BOARD ACTION REPORT – APPEALABLE ITEM

Project Name: 707 SE 1st Street
Project Location: 707 SE 1st Street, Marina Historic District
Request: Certificate of Appropriateness (2019-229)
Board: Historic Preservation Board
Meeting Date: October 2, 2019

HISTORIC PRESERVATION BOARD STAFF REPORT

707 SE 1st Street

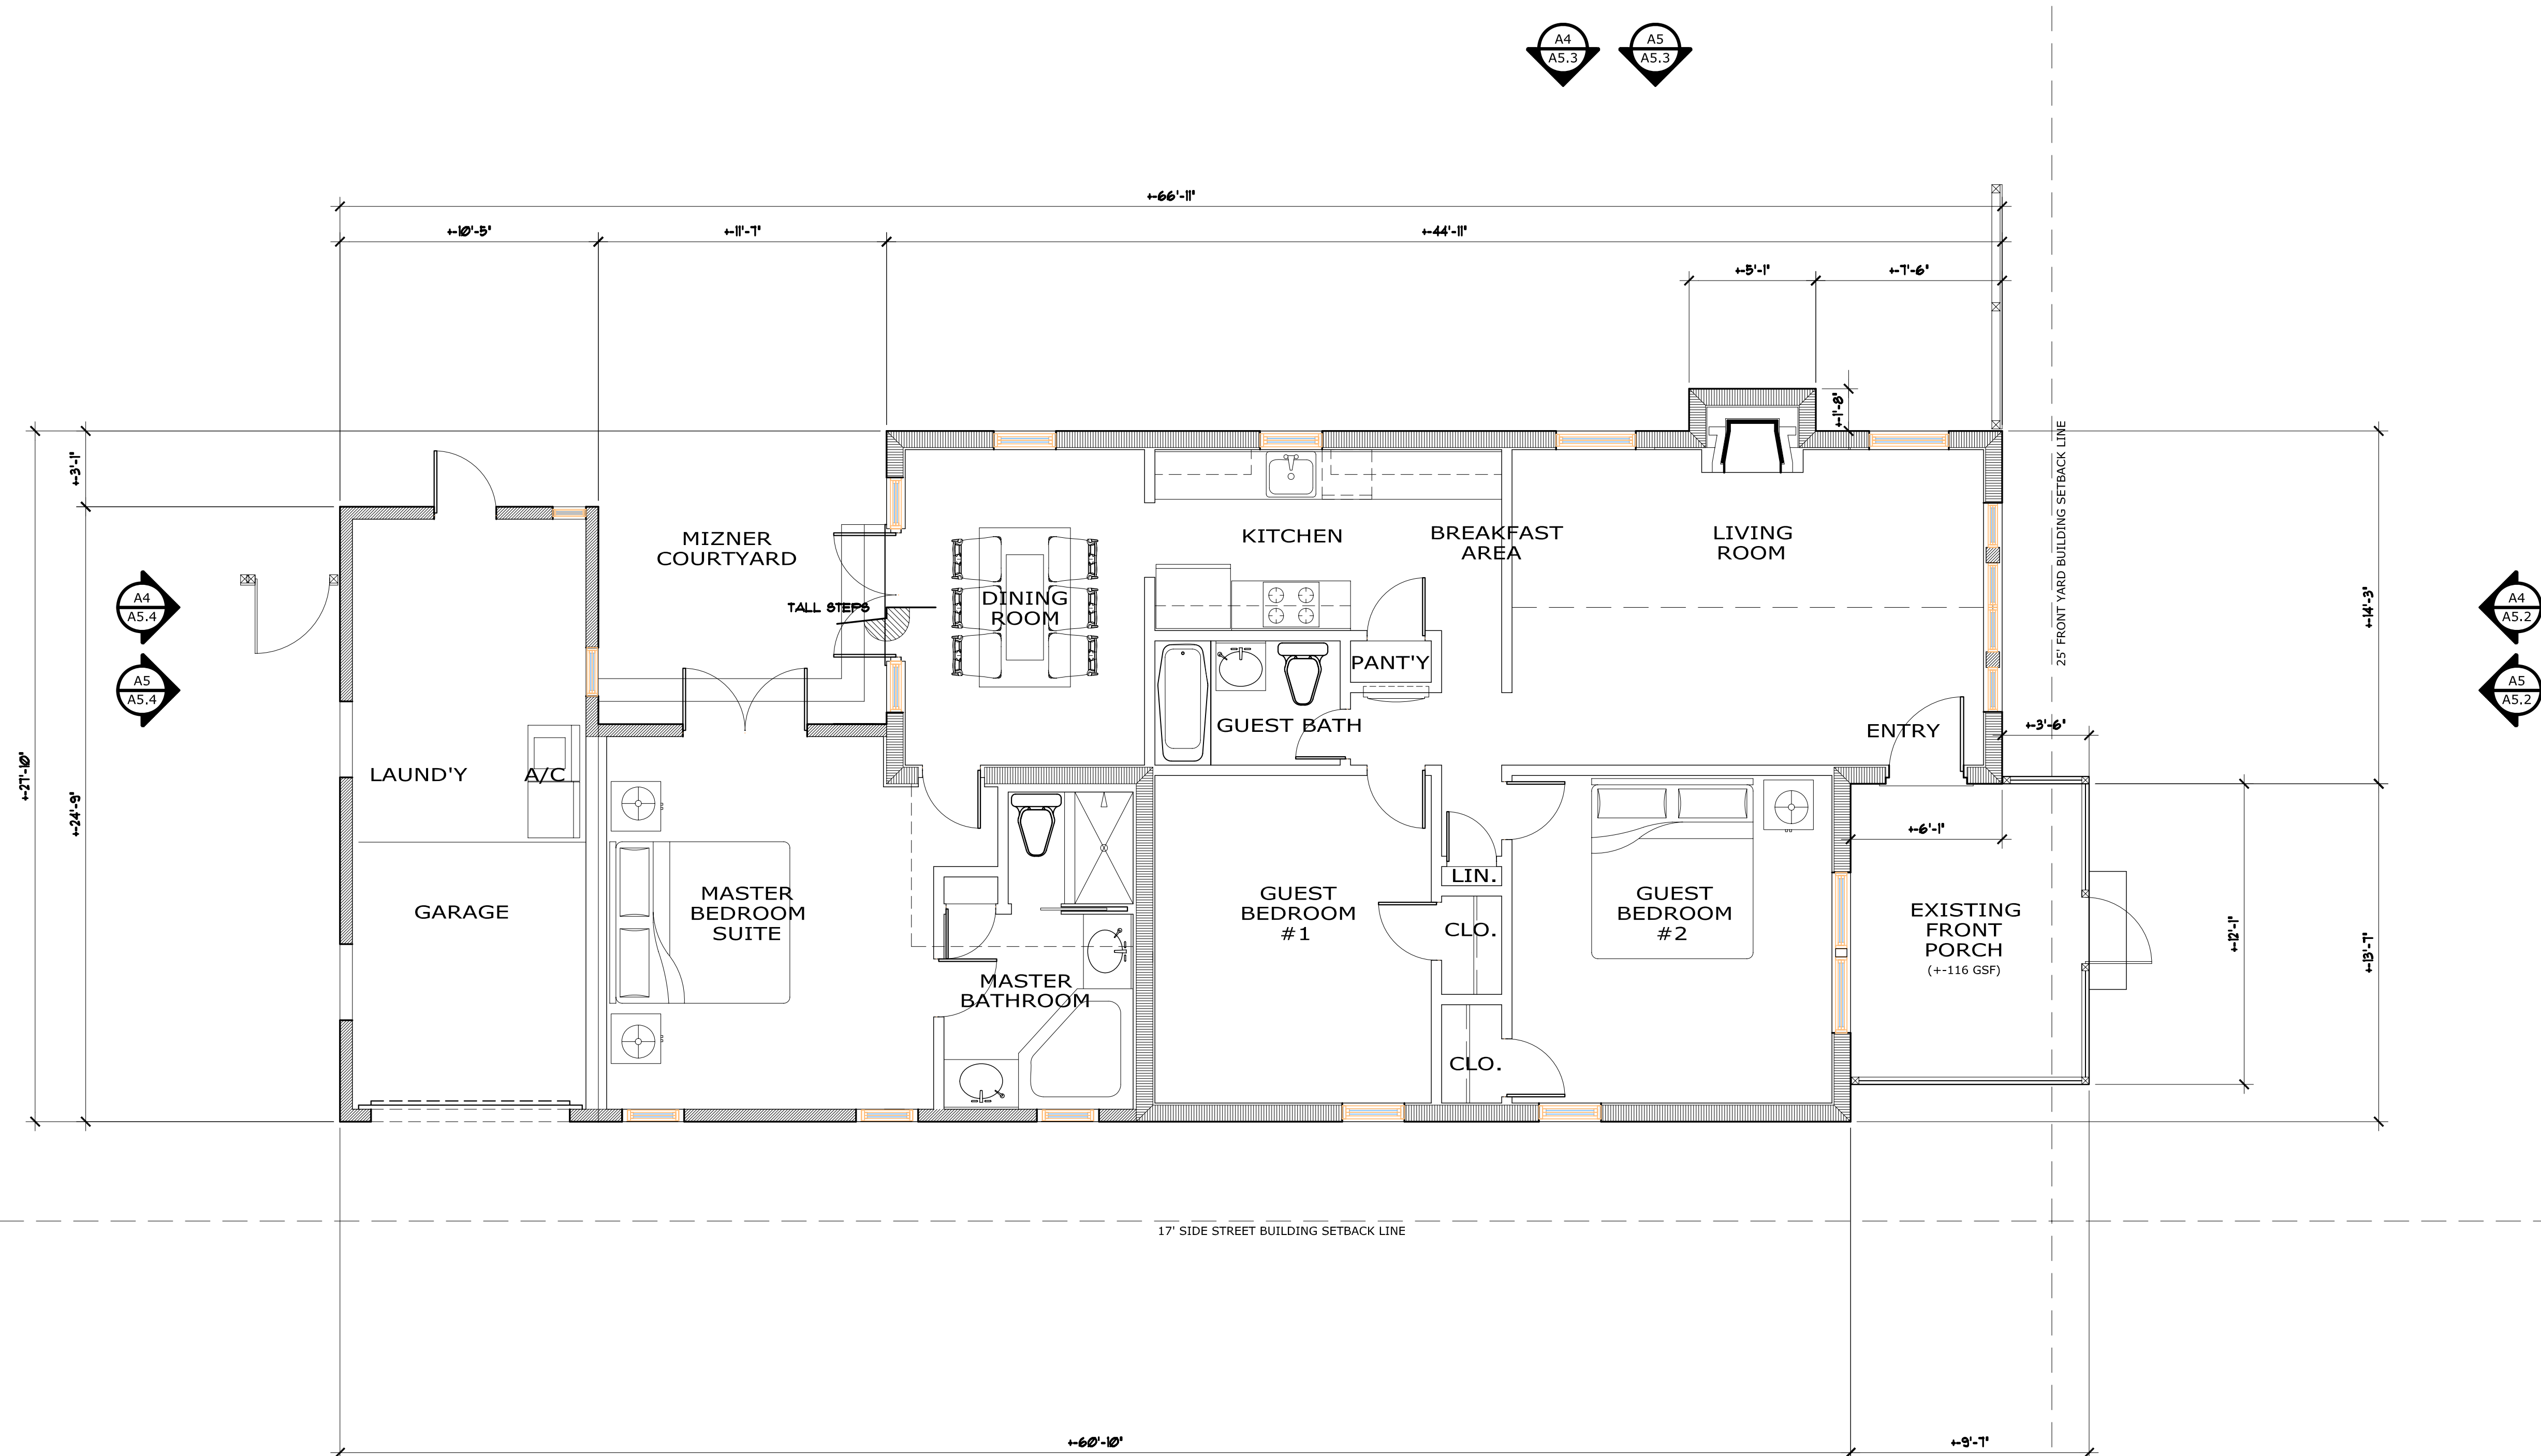
1. Illustrate and depict the approximate location of intersecting lot lines of adjacent parcels and the approximate location of the nearest structure and/or significant improvements on those parcels on the survey and site plan;
2. Illustrate and depict approximate location of aboveground or underground utilities (includes water, sewer, drainage, power, gas, telephone, and cable; poles and guy wires, transformer boxes, etc.).

- 1. Illustrate and depict the approximate location of intersecting lot lines of adjacent parcels and the approximate location of the nearest structure and/or significant improvements on those parcels on the survey and site plan;

2. Illustrate and depict approximate location of aboveground or underground utilities (includes water, sewer, drainage, power, gas, telephone, and cable; poles and guy wires, transformer boxes, etc.).

A5 HISTORIC MIZNER COTTAGE; EXISTING SOUTH ELEVATION

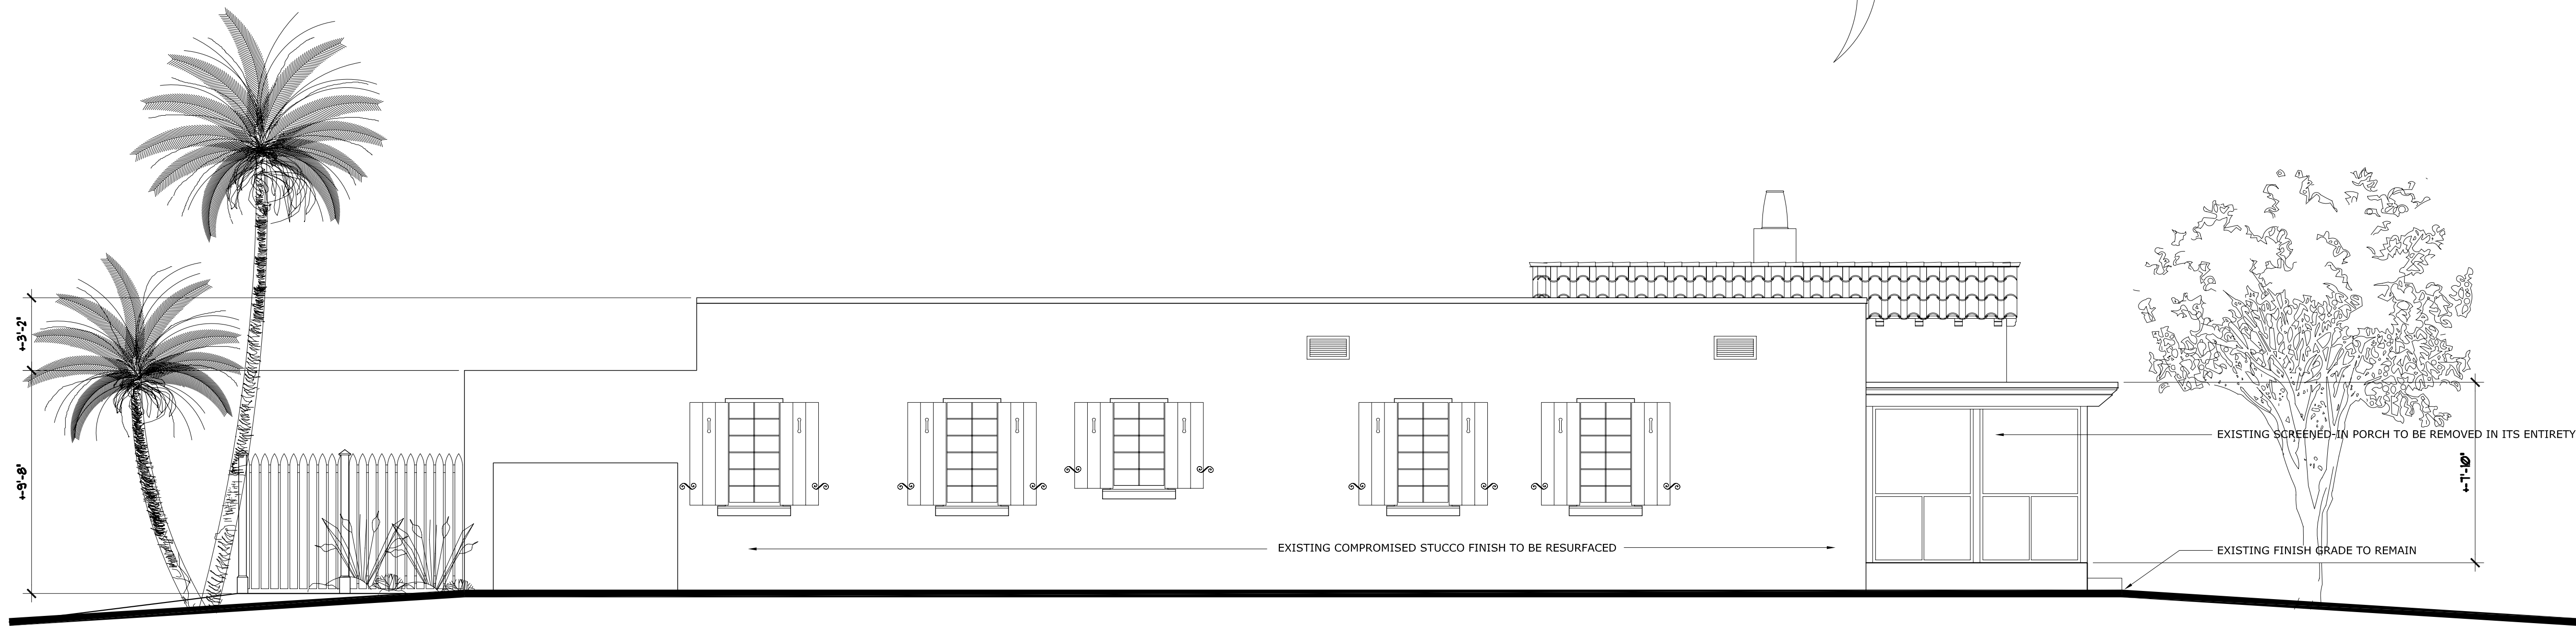
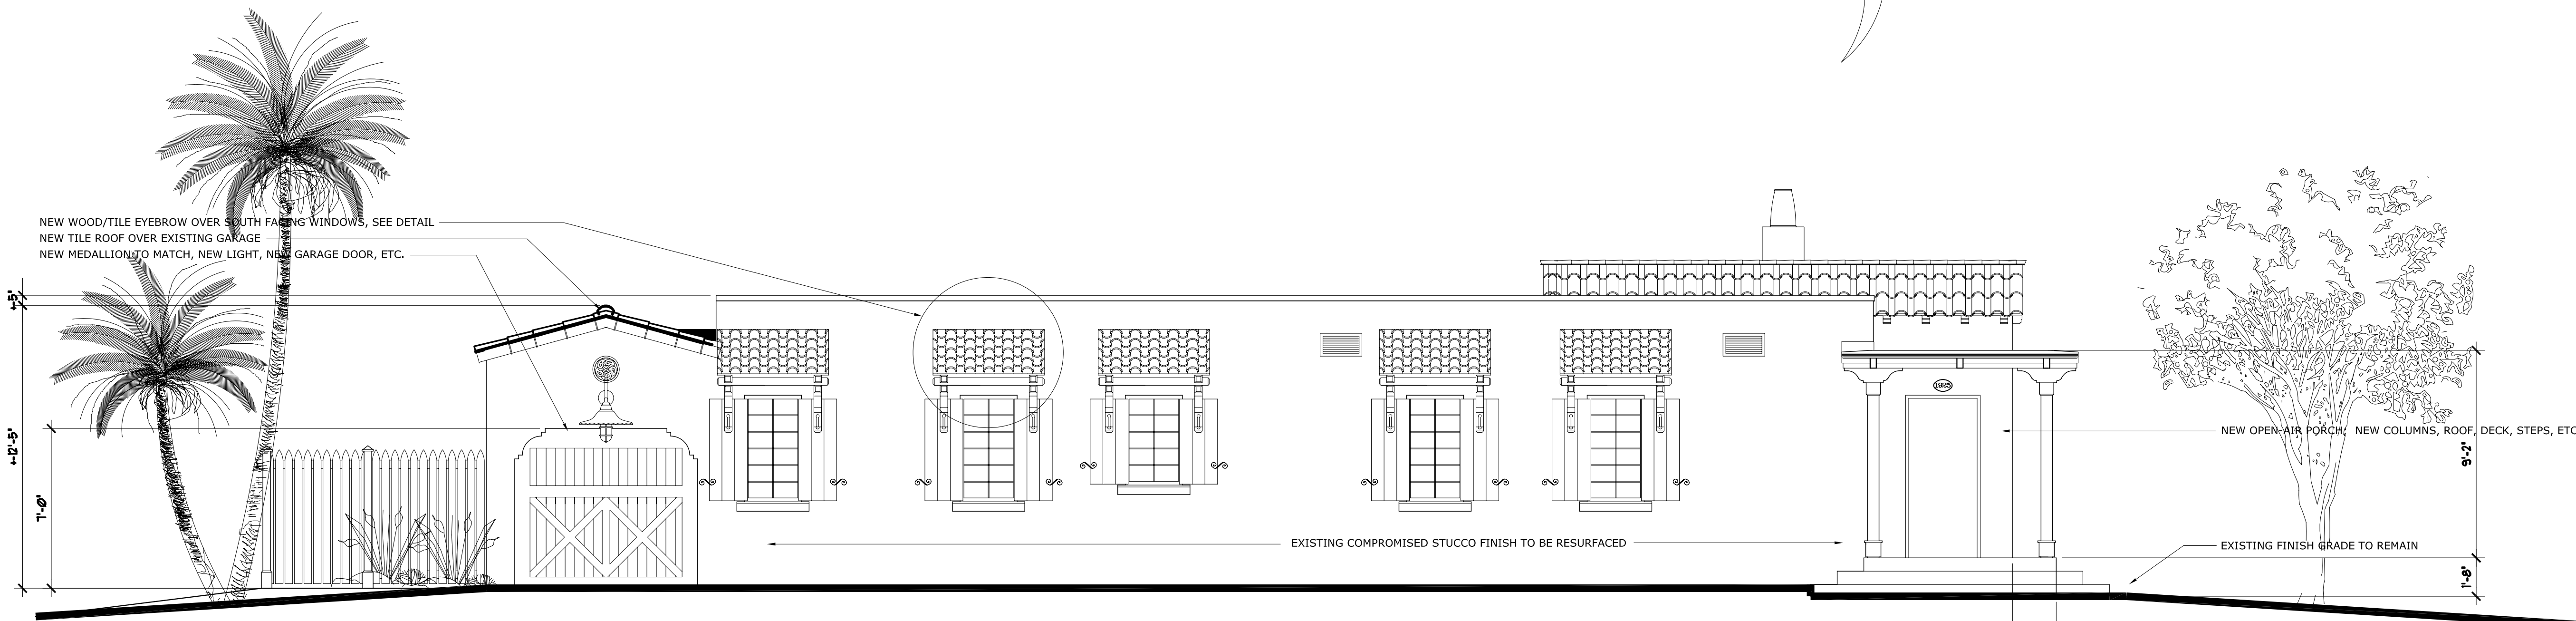
1. That the elevation drawings be revised to accurately depict the existing muntin/grid pattern of all existing windows;
2. That the shutters be removed from the south facing windows to accommodate proposed pent roof features; and,
3. That the proposed medallions be removed.

Standard 1, 2, 3, 5, 9, & 10 are applicable. The proposal includes the removal of the non-original screened-in porch from the front of the structure (east side) and construction of a new open-air, wood, trellis covered porch. The existing porch detracts from the façade, obscuring view of the front windows. The new porch is obtrusive. Also proposed is a new gable, barrel tiled roof on the one-car garage as well as replacement of the garage door. The garage was not original to the structure and was added many years later. Other architectural modifications include new barrel tile pent roofs above each of the south facing windows. These windows have wood shutters

and shutter dogs, which are existing. The new pent roofs are proposed to be installed over the shutters, “locking” them in place. Pent roofs are not architectural features that were originally depicted on this contributing Spanish bungalow style structure. To incorporate a new feature would be conjectural as it creates a false sense of history. According to the standards, it is not recommended as an appropriate practice of historic preservation. The residence does have original Spanish style architectural influence as was typical of Mizner designed architecture, which is demonstrated by the barrel tile roof on the front (east) elevation; however, this original Mizner structure was designed to be a simple representation of the style. . The introduction of more elaborate architectural details such as the pent roofs, is not appropriate for this modes style Spanish bungalow. A condition of approval is added to remove the proposed pent roof features from the south facing windows.

With regard to the Proportion of Openings (Windows and Doors) the, windows on site plan are all depicted as six-over-six muntin pattern; however, the windows on the south elevation exist with a one-over-one muntin pattern. The proposal does not include replacement of the existing wood windows, therefore, the illustration of windows with a six-over-six muntin pattern appear to be in error. The elevations should be revised to accurately depict the existing one-over-one muntin pattern; this item is added as a condition of approval.

With regard to Architectural Style, the proposed pent roofs represent an introduction of the more elaborate Mediterranean Revival architectural style. Another architectural feature that is being introduced are medallions. One medallion is proposed on the front gable and another on the new gable above the garage. The structure is a modest Spanish bungalow that was designed by Addison Mizner to be simplistic in style and nature. The original architectural detailing was limited. As required by the visual compatibility standards, all development shall consist of only one (1) architectural style per structure and shall not introduce elements definitive of another style. In order to preserve the original simplistic style of the structure, the pent roofs and medallions must be eliminated from the proposal.
